Compliance with Approval Condition (f) Submission of a drainage proposal

Proposed Temporary Public Vehicle Park (Excluding Container Vehicle) and Shop and Services for a Period of 5 Years in “Village Type Development” Zone, Lots 139 (Part) and 145 in D.D. 96, Pun Uk Tsuen, San Tin, Yuen Long
(Planning Application No. A/YL-ST/642)

Appendix I – Response to Comments of the Chief Engineer/Mainland North, Drainage Services Department (CE/MN, DSD)

Title: Drainage Proposal D01

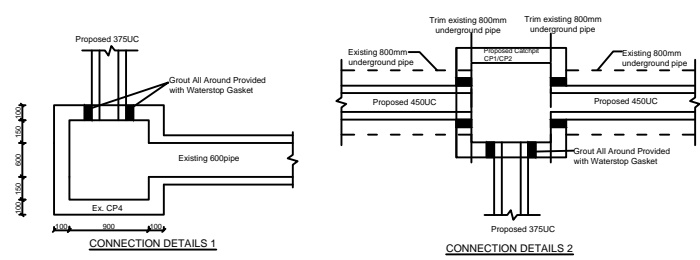
Comments of the CE/MN, DSD (Contact Person Mr. Jacky LEONG; Tel: 2300 1432)		
(i)	The drainage impact on the existing drainage system is not addressed in the submitted drainage proposal. The applicant shall show that the additional run-off from the development, if any, would not cause insurmountable drainage issue.	The outside catchment area has been considered and corresponding calculation checking is revised for your consideration please (Appendix II).
(ii)	Refer to Stormwater Design Manual Section 6.6.1, in any case, the impact of a 50-year event should be assessed in the planning and design of village drainage system to check whether a higher standard than 10 years is justified.	50-year return period is adopted and revised accordingly (Appendix II).
(iii)	My previous comment (e) is not addressed in your calculation. Please clarify.	Calculation checking of existing 800 pipe is presented at the revised drainage proposal (Appendix II).

Check existing 450UC as denoted by (e) in the Drawing D01

Calculation Maximum Capacity of Existing 800 pipe

Existing 800 pipe is OK
